**CASE No. 2021-00127**  
**RHUDES CREEK SOLAR, LLC**  
**RESPONSES TO SITING BOARD'S SECOND REQUEST FOR INFORMATION**

**CASE No. 2021-00127**  
**RHUDES CREEK SOLAR, LLC**  
**RESPONSES TO SITING BOARD'S SECOND REQUEST FOR INFORMATION**

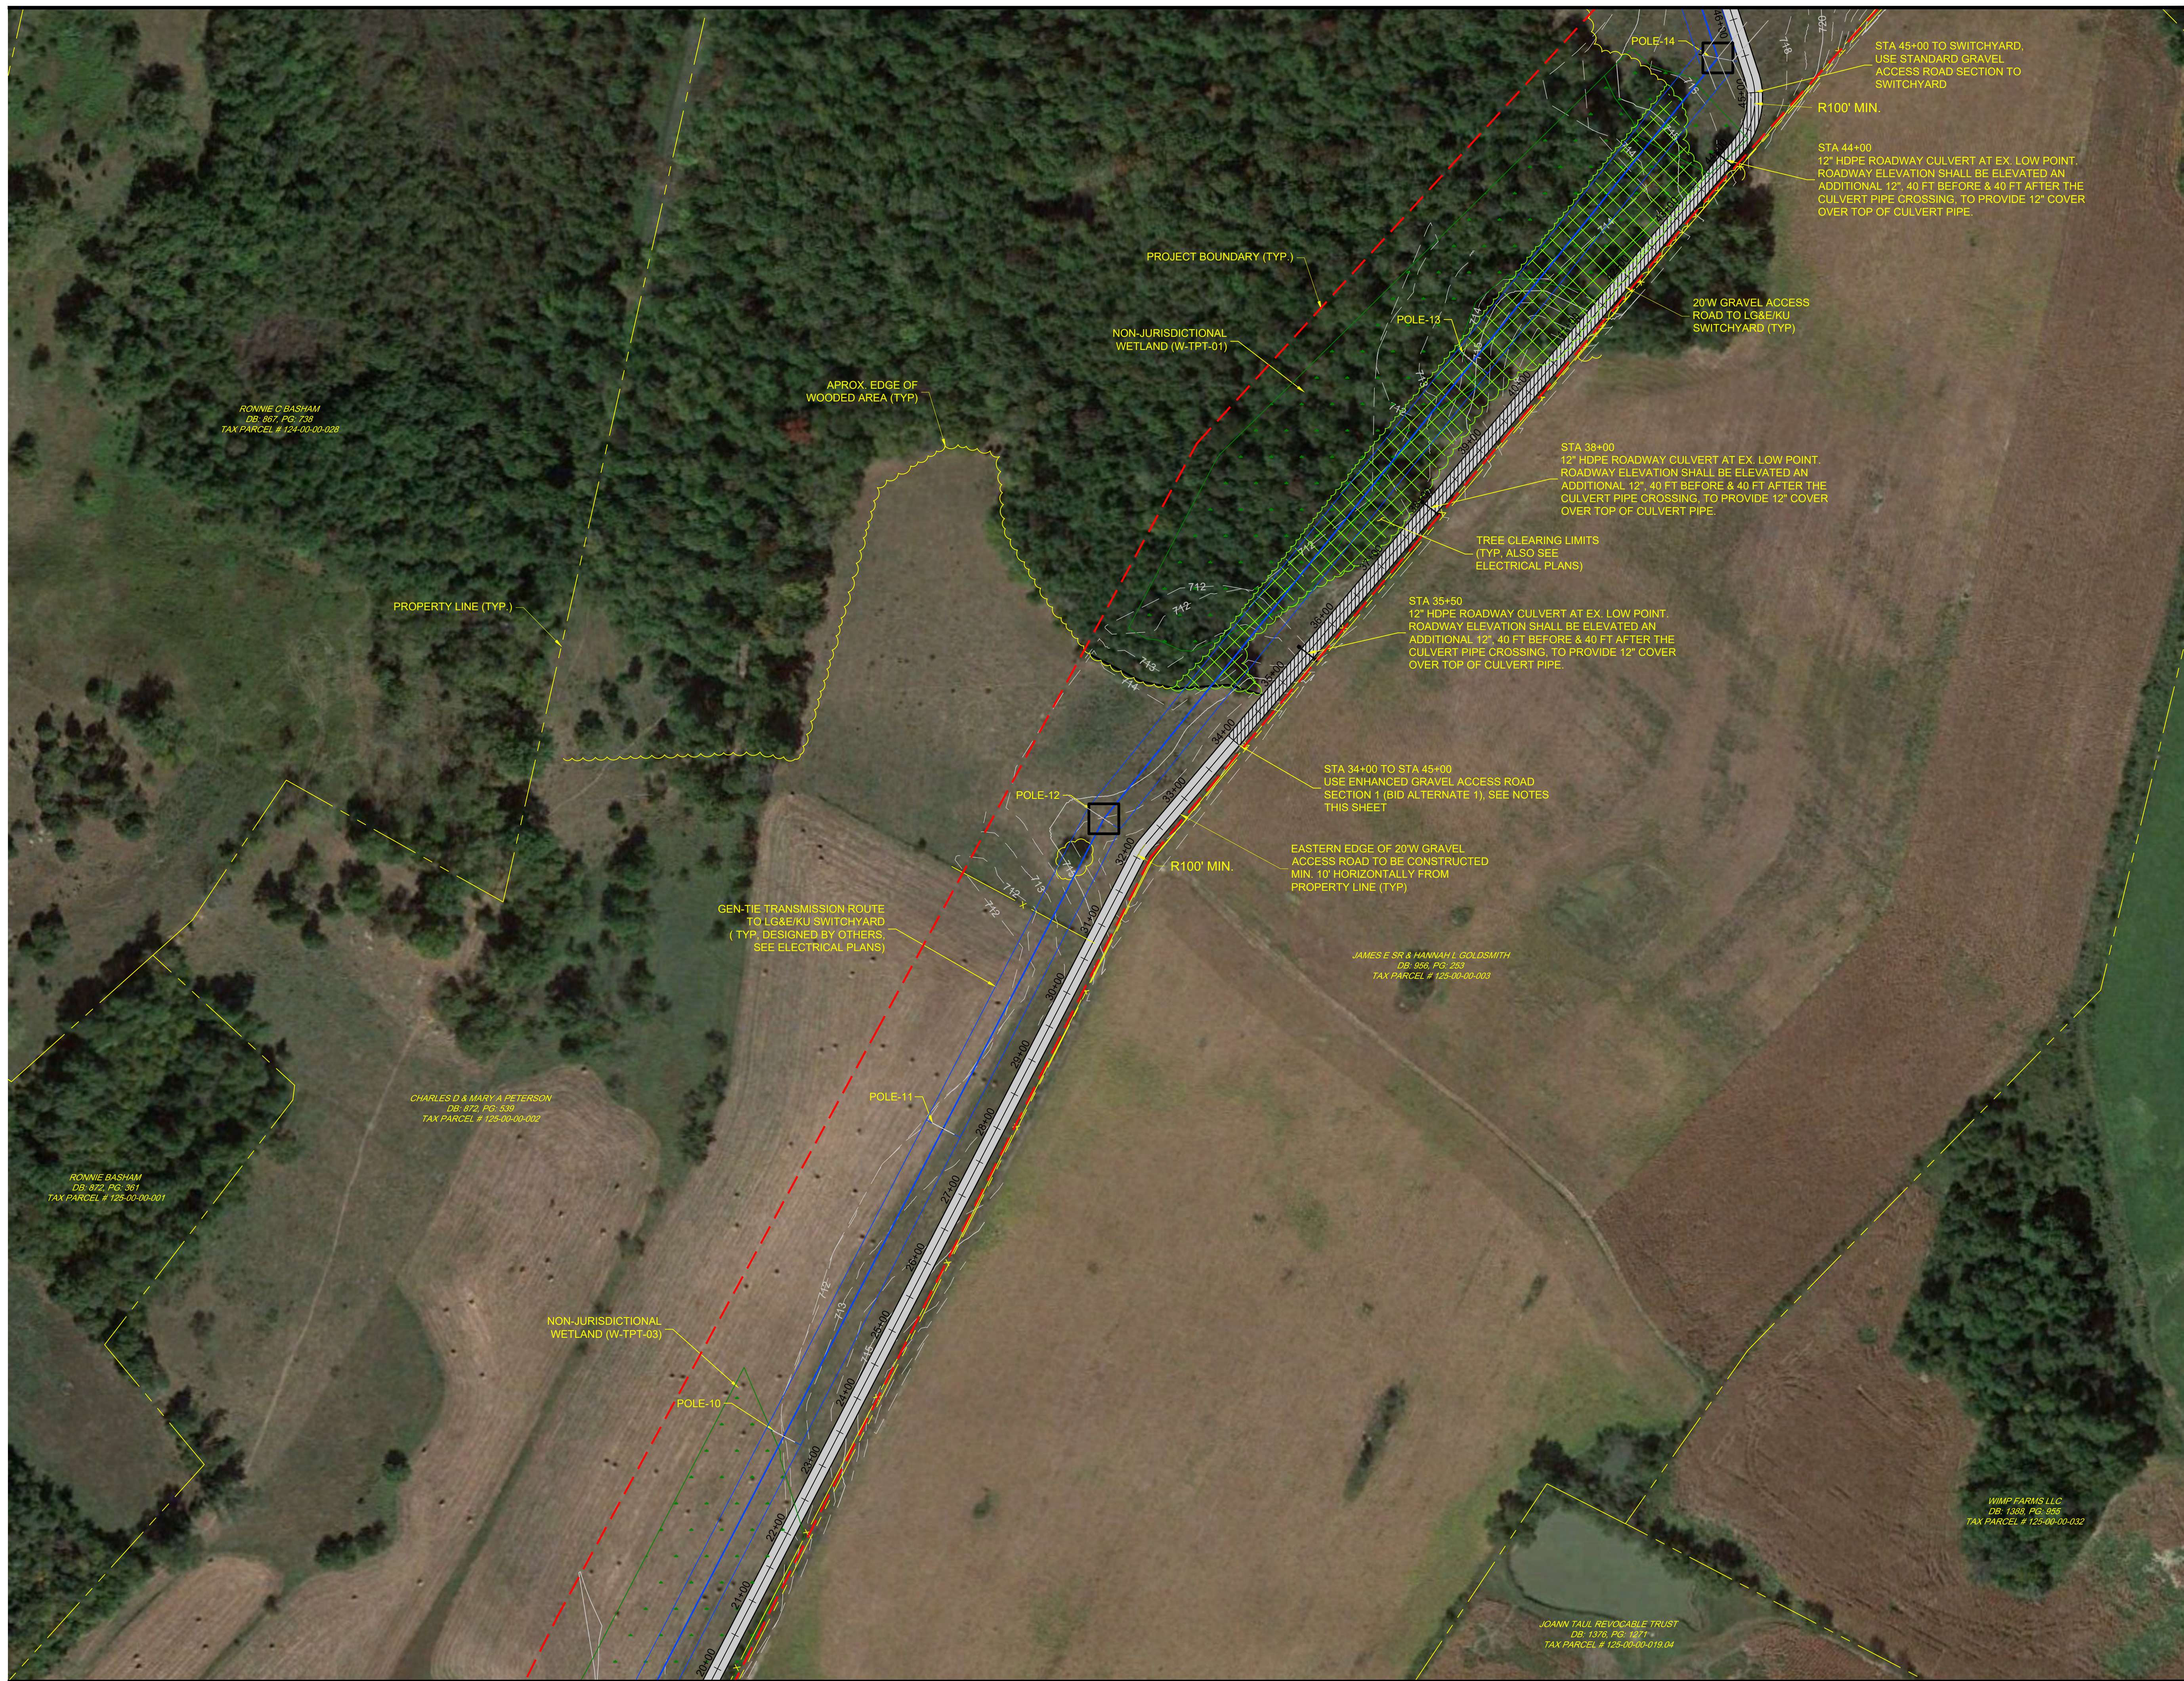
9. Explain what steps will be taken to avoid adverse effects to, or improve, the water run-off flow pattern currently occurring in front of and on the Fraser property at 3562 Hardinsburg Road. Include any measures designed to avoid interference with the free flow of runoff water from surrounding property that now exists. Address this both during construction and during operation of the facility and the newly built transmission line.

**Response: An 18-inch roadway culvert in the state highway right-of-way and a 12-inch culvert adjacent to the Fraser property have been planned to allow the free flow of runoff water. Please see page 4 and 5 of the attached Switchyard Access Plan Details.**

# Tucker's Pond Pre- and Post- Development Drainage Conditions

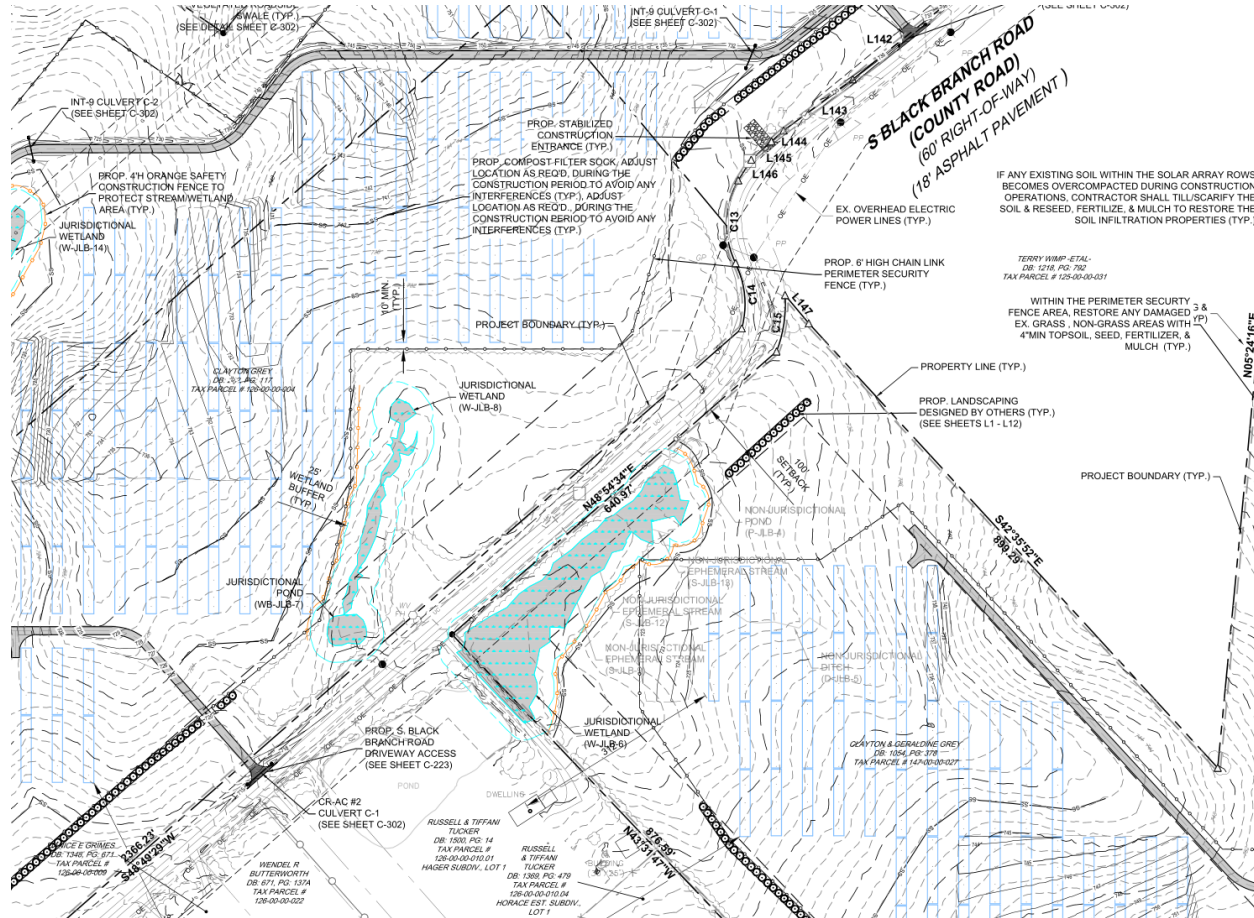
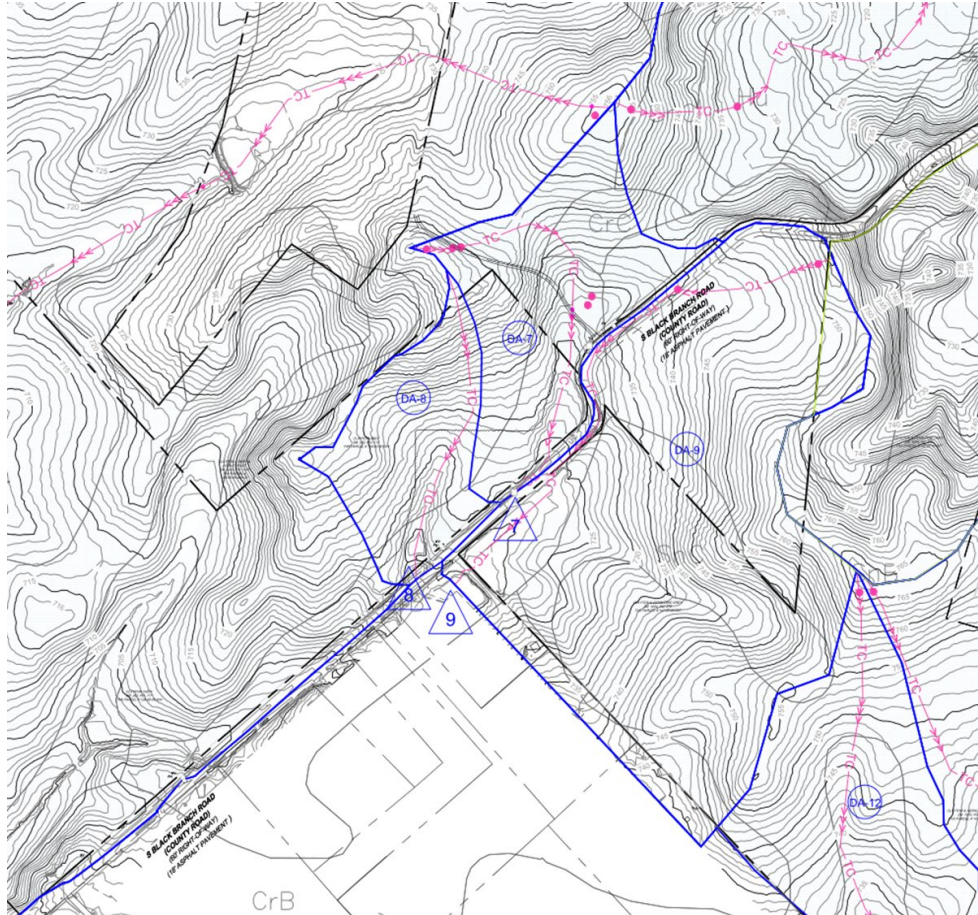
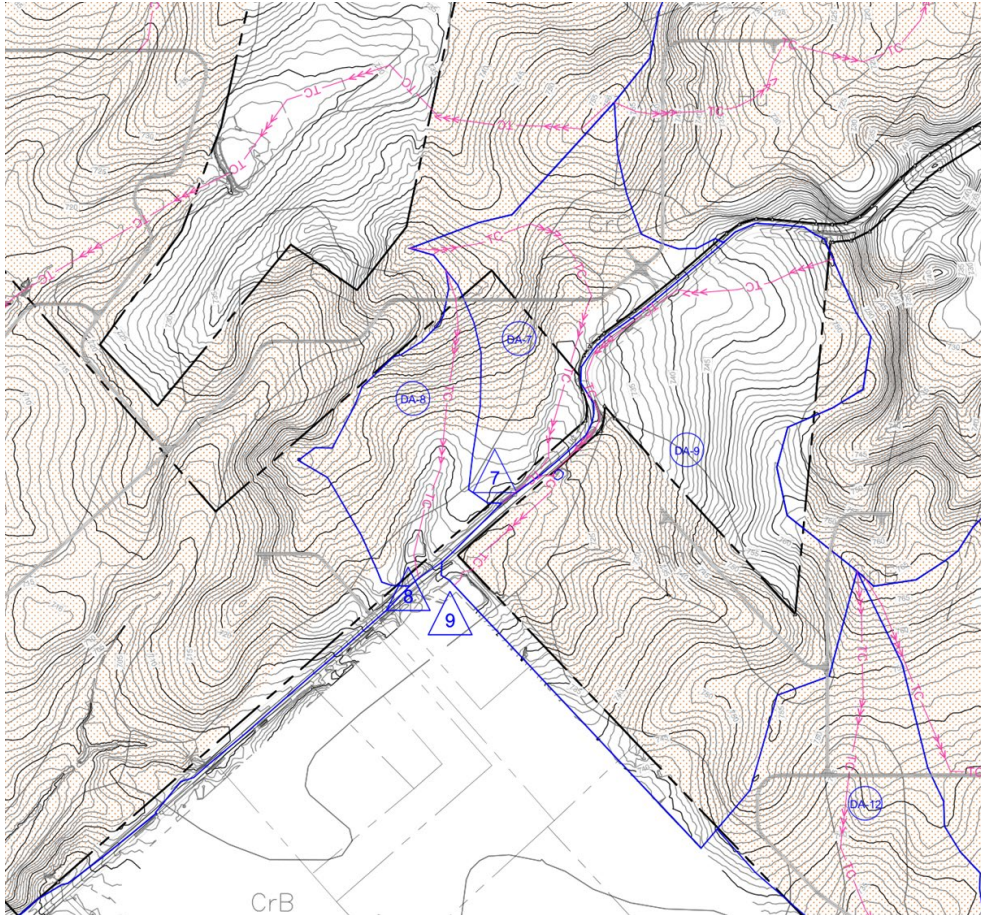
13. Describe any conversations with individual adjacent landowners regarding stormwater concerns, including the specific nature of their concerns and Rhudes Creek Solar's plans to address those concerns.

**Response:** Along with conversations with the Frasers, some of which are documented in Attachment F to the Application, numerous meetings and site visits have been conducted with Russell and Tiffani Tucker. A correspondence email and presentation are attached hereto for reference.
